CHILDREN'S HOSPITAL
OF ORANGE COUNTY

TOWER II Received
June 05 2012
McCarthy

LEVEL 4 REFLECTED
CEILING PLAN AREA - C

A4.4C

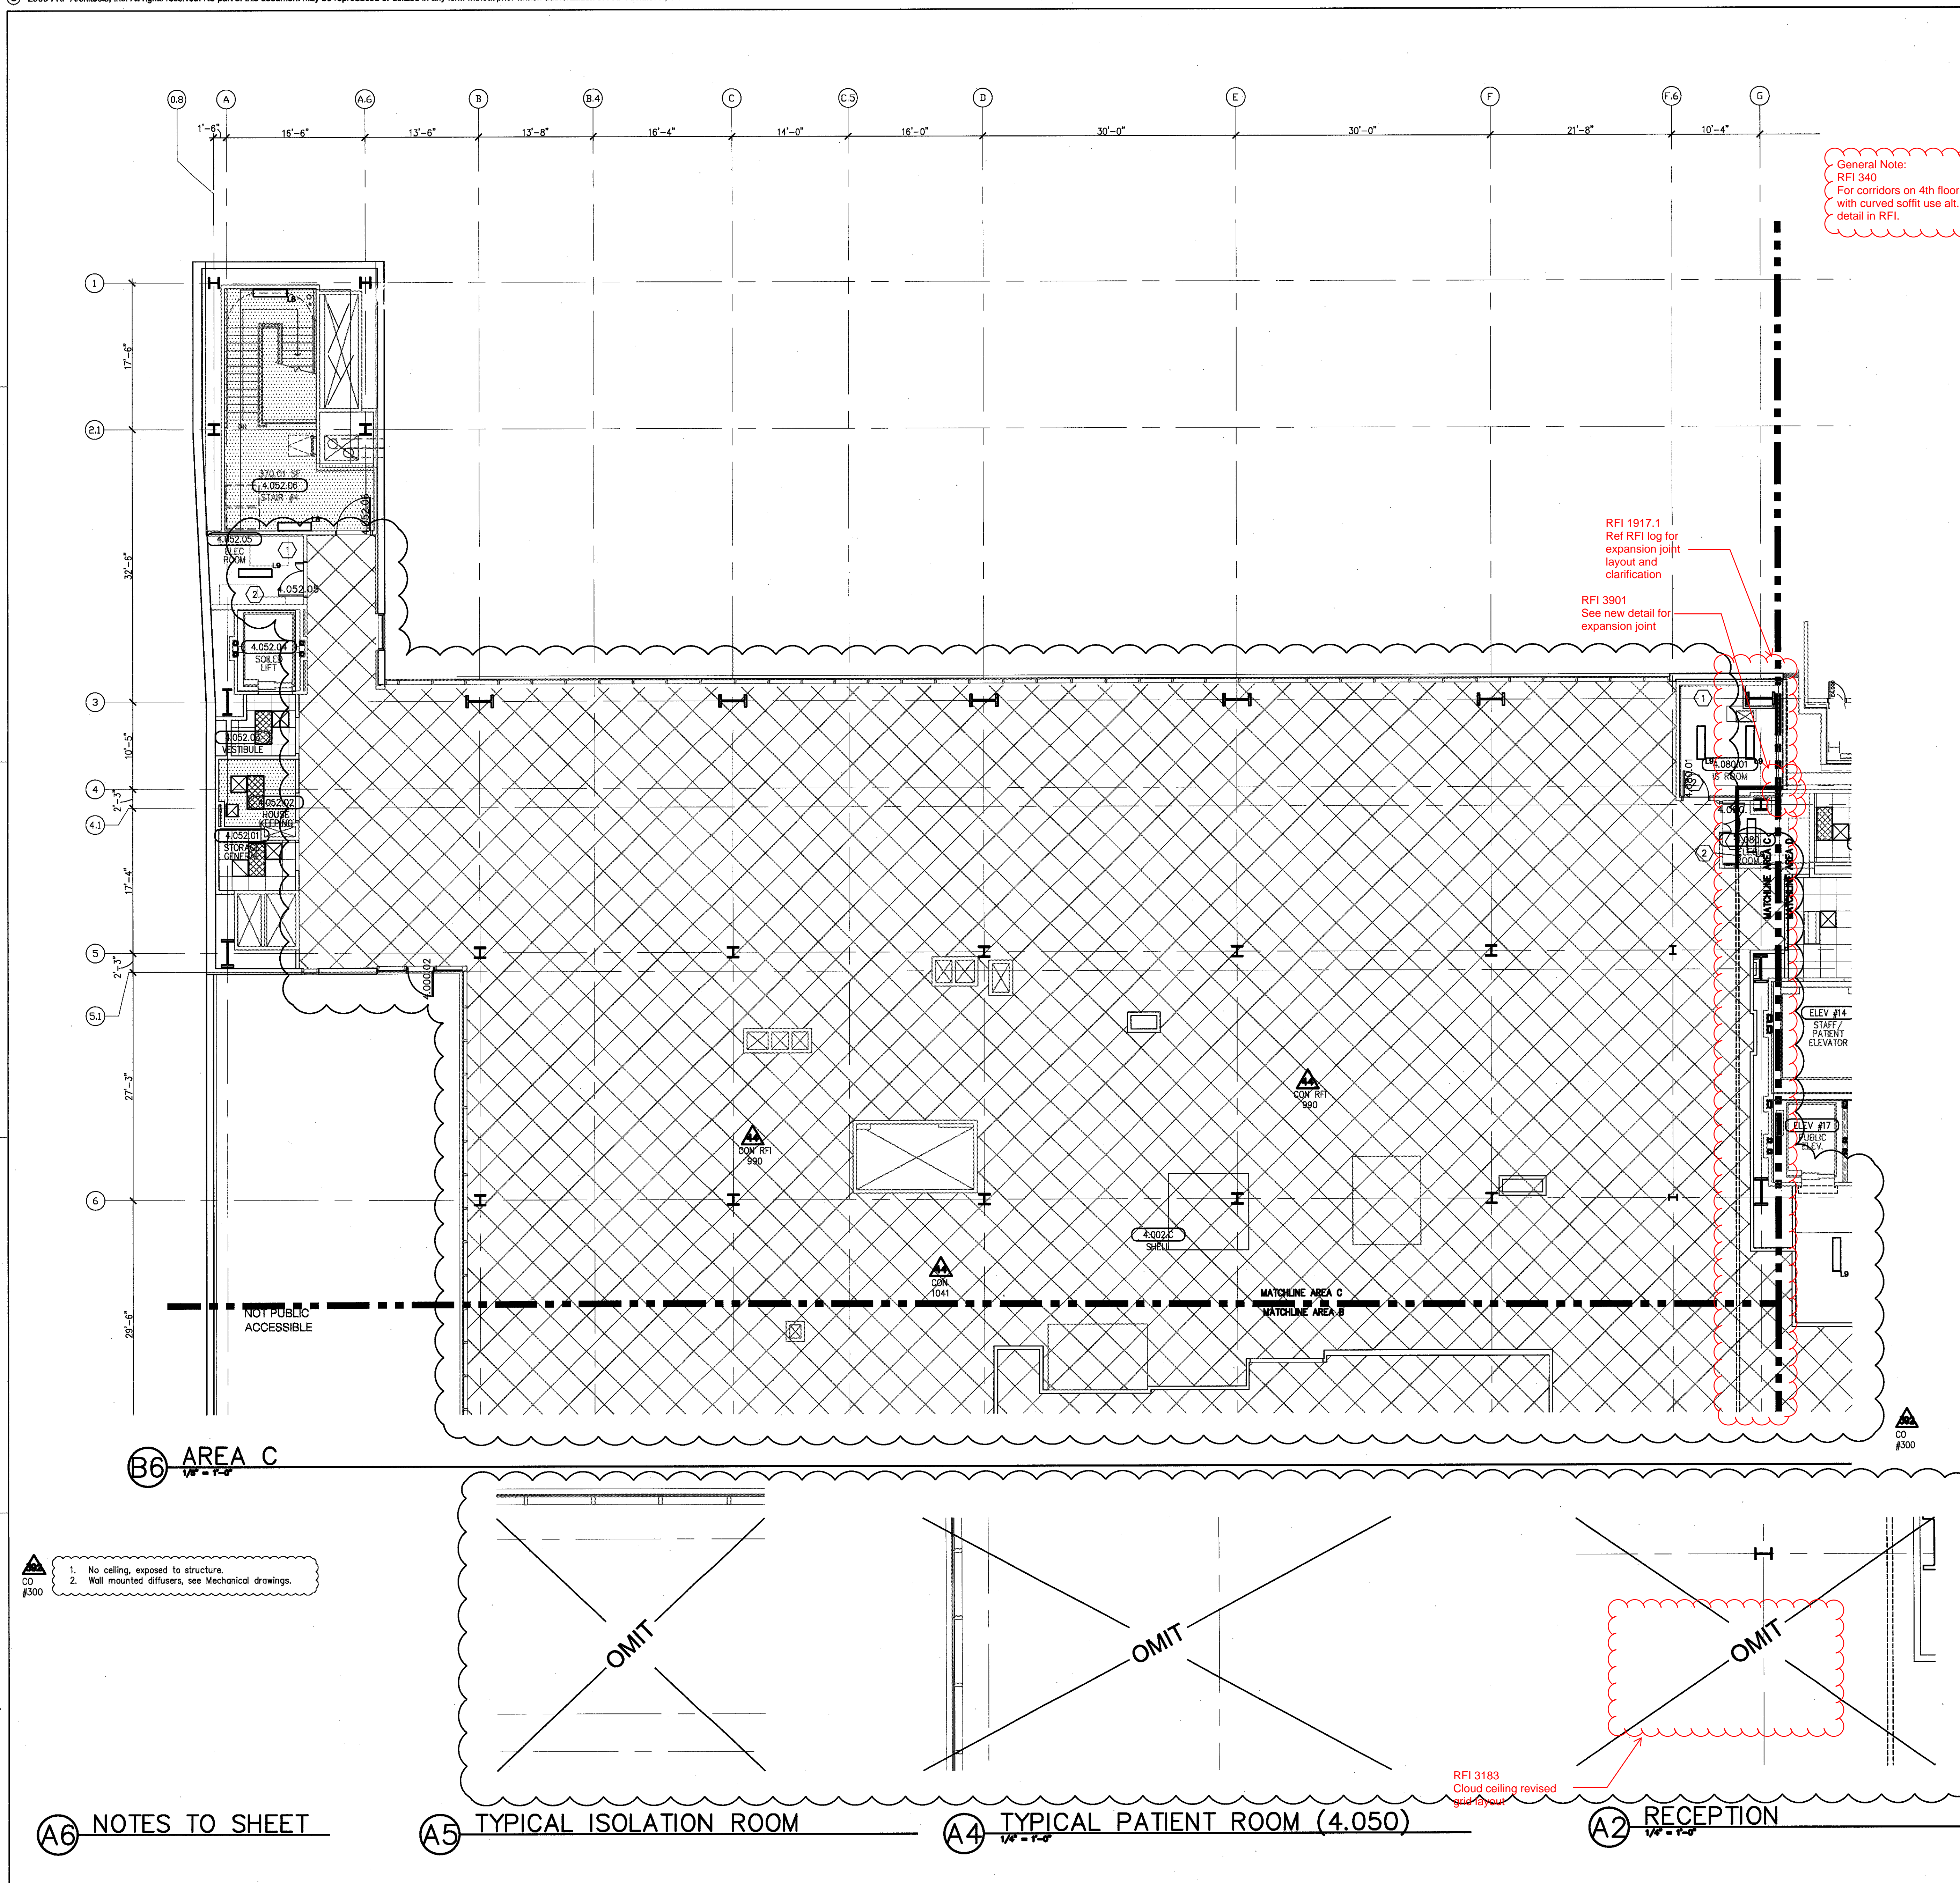
General Note:
RFI 340
For corridors on 4th floor
with curved soffit use alt.
detail in RFI.

RFI 1917.1
Ref RFI log for
expansion joint
layout and
clarification

RFI 3901
See new detail for
expansion joint

RFI 3183
Cloud ceiling revised
grid layout
